APPLICATION NO.	FILING DATE	FIRST NAMED INVENTOR	ATTORNEY DOCKET NO.	CONFIRMATION NO.
10/537,937	01/19/2006	Bruno Eigner-Walter	VAL 204 P2	8638
34232	7590	07/31/2008	EXAMINER	
MATTHEW R. JENKINS, ESQ. 2310 FAR HILLS BUILDING DAYTON, OH 45419			FERGUSON, MICHAEL P	
		ART UNIT	PAPER NUMBER	
		3679		
		MAIL DATE	DELIVERY MODE	
		07/31/2008	PAPER

<b>Office Action Summary</b>	<b>Application No.</b> 10/537,937	<b>Applicant(s)</b> EGNER-WALTER ET AL.
	<b>Examiner</b> MICHAEL P. FERGUSON	<b>Art Unit</b> 3679

### **DETAILED ACTION**

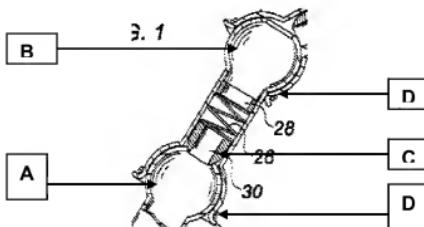
a first ball **A,12** (Figure 1 reprinted below with annotations); and  
a first pin **30** integrally formed with the first ball (pin **30** is formed to function as a single unit with ball **12**; thus the pin is integrally formed with the ball; Figure 1);

a second ball **B,12** having a second pin **C,30** integrally formed with the second ball and mounted into a first recess **32** of the first ball (pin **30** is formed to function as a single unit with ball **12**; thus the pin is integrally formed with the ball; Figure 1);

the first ball and the second ball having a first ball cup **D,14** an a second ball cup **E,14**, respectively, mounted thereon, the first and second ball cups being pivotable or rotatable with respect to the first and second balls, respectively;

the first ball comprising the first recess situated generally opposite first pin, the first recess having a recess dimension and the first in having a pin dimension, the pin dimension being at least as large as the recess dimension (a dimension of pin **30** is at least as large as recess dimension **32** so that the pin is received within the recess;

Figure 1; column 4 lines 29-32).

As to claim 15, Hathaway discloses a ball pin system wherein the second ball **B,12** comprises a second recess **32** situated generally opposite the second pin **C,30**; the first and second balls **12** and the first and second recesses **32** being generally coaxial when the second ball is mounted onto the first ball (Figure 1).

As to claim 16, Hathaway discloses a ball pin system wherein the first ball cup **14** is molded onto the first ball **A,12** (ball cup **14** fits the contours of ball **12**, thus the ball is molded onto the first ball; Figure 1).

As to claim 18, Hathaway discloses a ball pin system wherein the second ball cup **E,14** comprises a stop **30** that is received in the second recess **32** to facilitate limiting a rotation of a rod **10** coupled to the second ball cup (Figure 1, column 3 lines 20-24).

As to claim 19, Hathaway discloses a ball pin system wherein the first ball **A,12** comprises a first diameter and the second ball **B,12** comprises a second diameter, the first and second diameters being the same (Figure 1).

As to claim 22, Hathaway discloses a ball pin system wherein the second pin **C,30** has a second pin dimension, the second pin dimension being substantially the same as the recess dimension so that the second pin may be press fit into the first recess **32** (Figure 1).

As to claim 20 and 21, Hathaway does not disclose any structural or functional significance as to the specific size of the first and second balls **12** (Figure 1). Hathaway fails to disclose a ball pin system wherein the first ball comprises a first diameter and the second ball comprises a second diameter, wherein the second diameter is smaller than the first diameter.

Examiner disagrees. As to claim 11, Hathaway discloses a ball pin wherein the recess **32** has a recess diameter that is substantially the same as a diameter of the pin **30** of the ball pin (pin **30** is formed to function as a single unit with ball **12**; thus the pin is integrally formed with the ball; a diameter of pin **30** is substantially the same as recess diameter **32** so that the pin is received within the recess; Figure 1; column 4 lines 29-32).
